Reference: Contract F11623-94-D0024, Delivery Order RL17
Item No. 3.0.2, Technical Interchange Meeting
Camp Stanley Storage Activity (CSSA) SWMU Closures and
Integrated Spill and Waste Management Plan
Meeting Minutes 5 (Item 5.2.4; A007)

MEETING MINUTES

Subject: Project status to date

Response to comments from Booz-Allen & Hamilton, Inc.
 Draft Report for the Evaluation of Background Metals Concentrations in
 Soil Types at Camp Stanley Storage Activity (CSSA)

ATTACHMENT 3
OBSERVED PRESSURE RESPONSES WHEN EXTRACTING FROM VEW4 AND VEW5
FEB. 1997
CAMP STANLEY STORAGE ACTIVITY

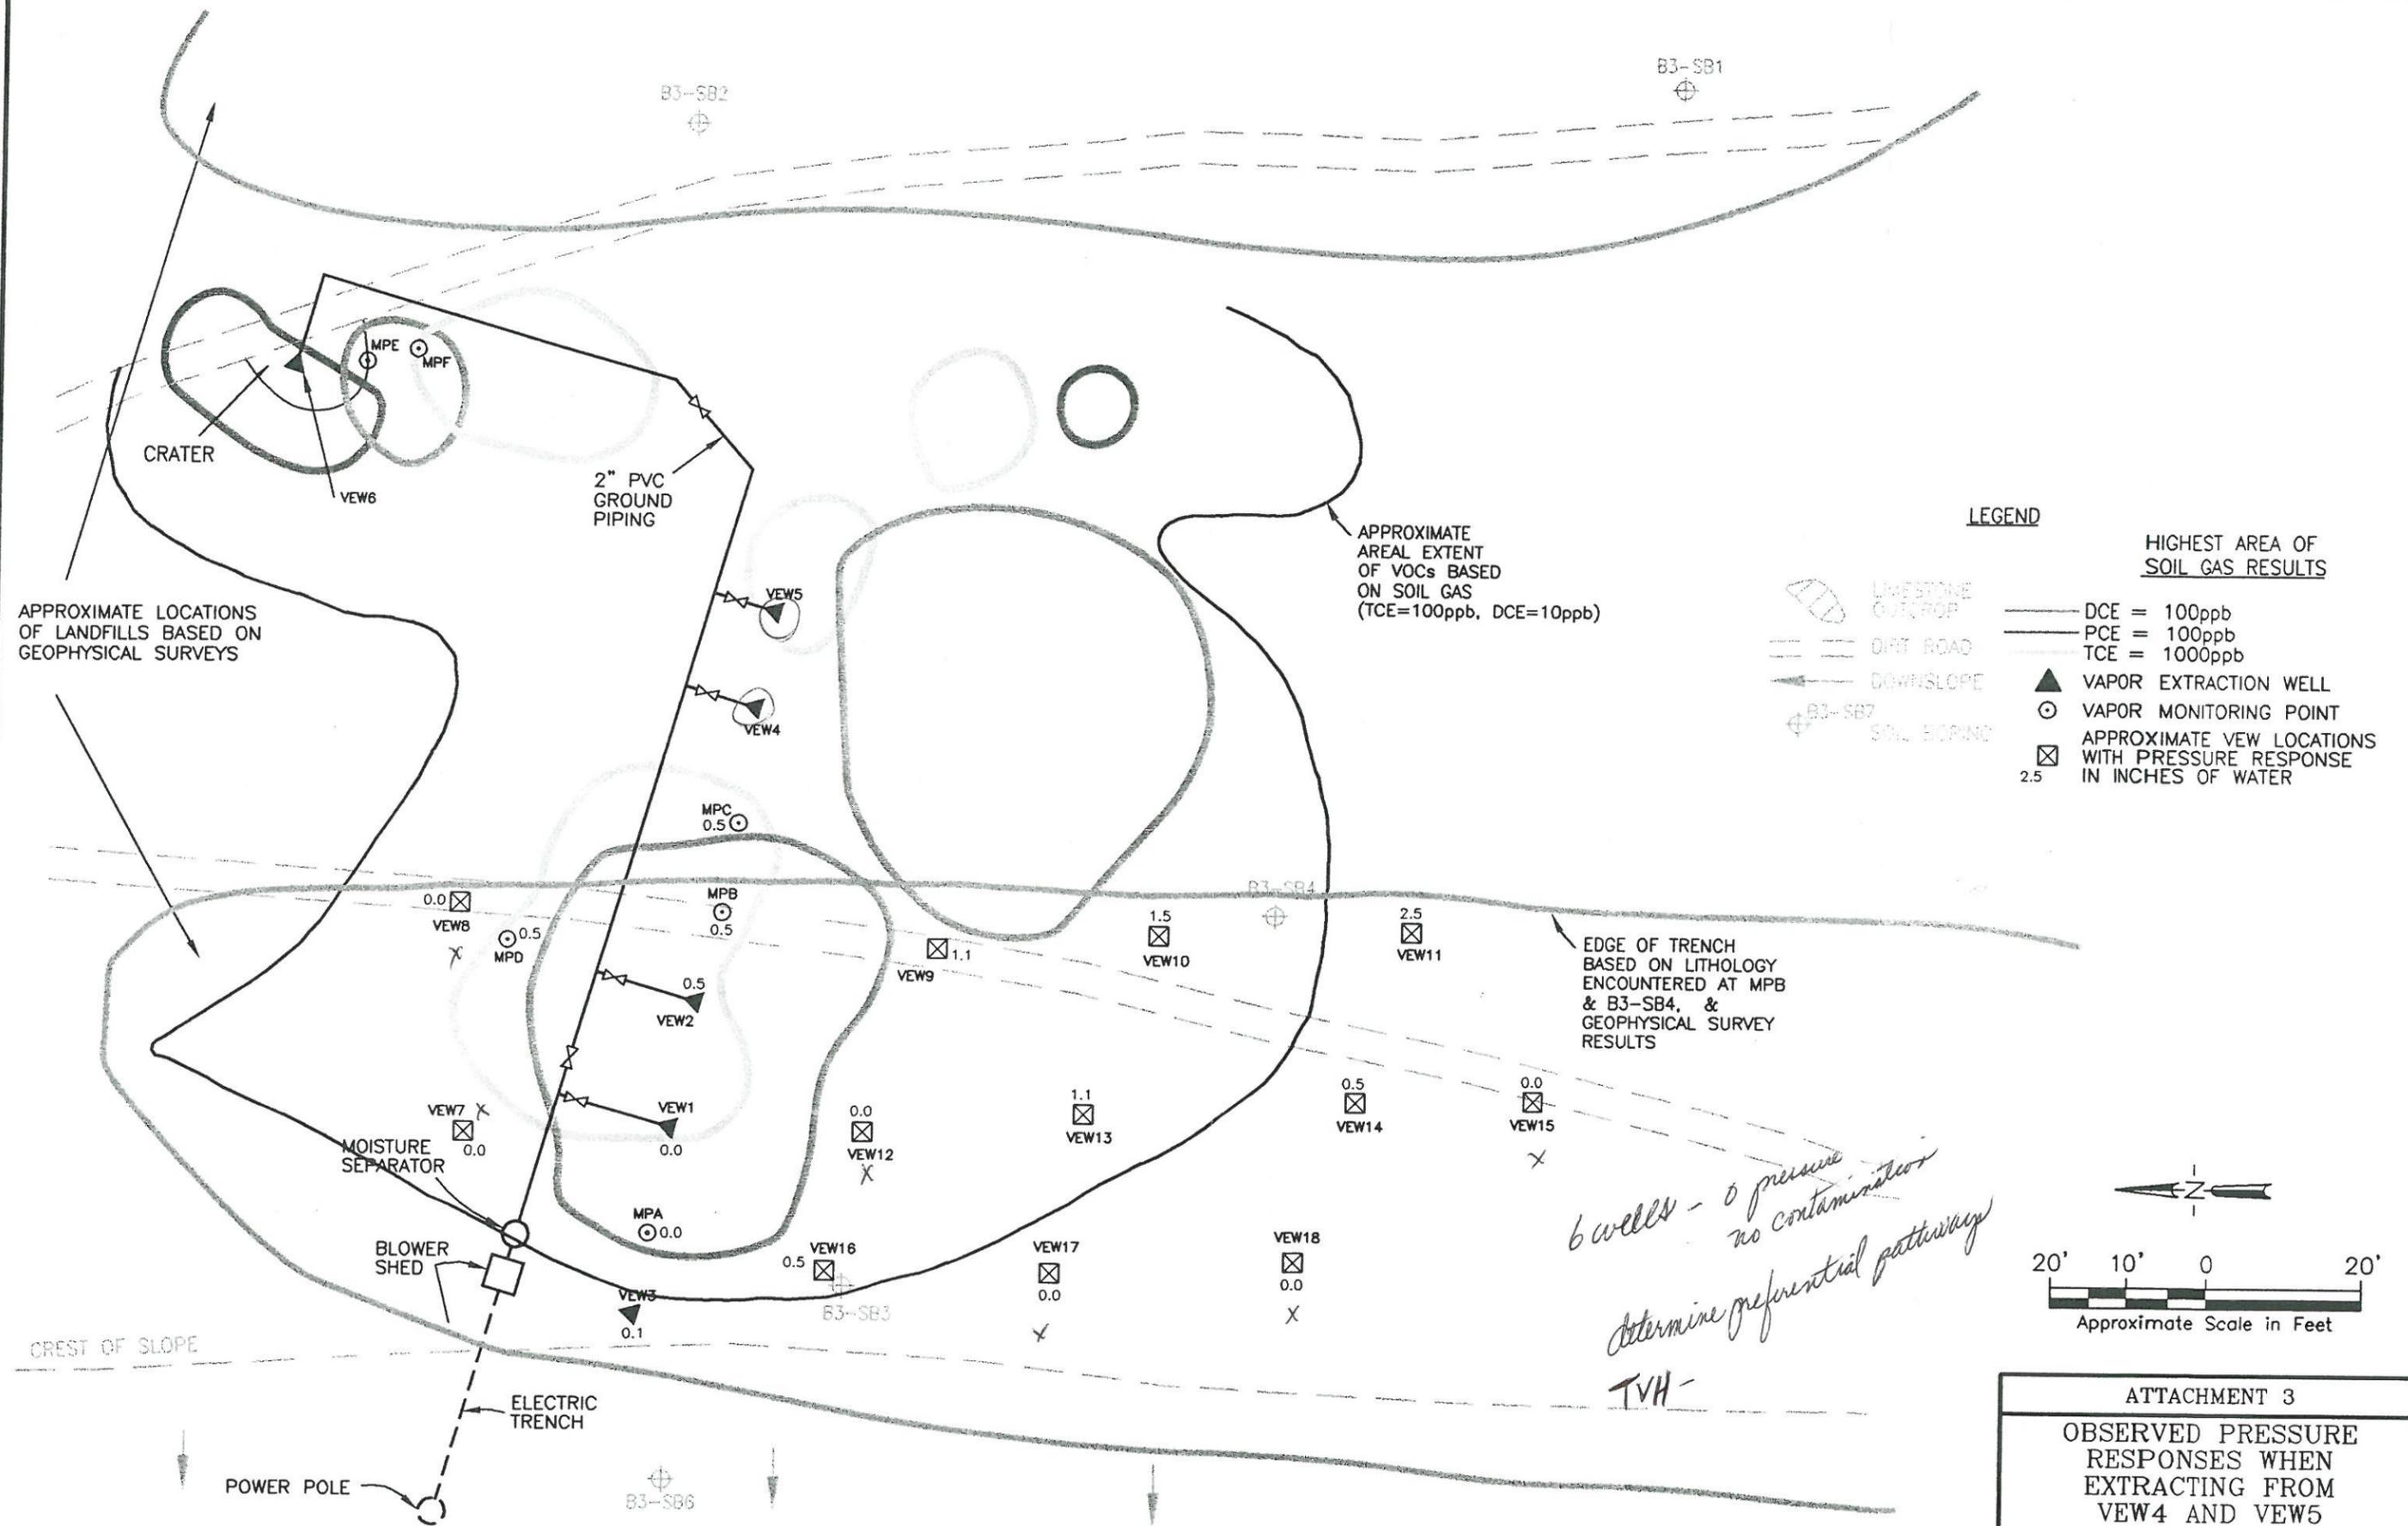
*6 wells - 0 pressure
no contamination
determine preferential pathways
TVH-*
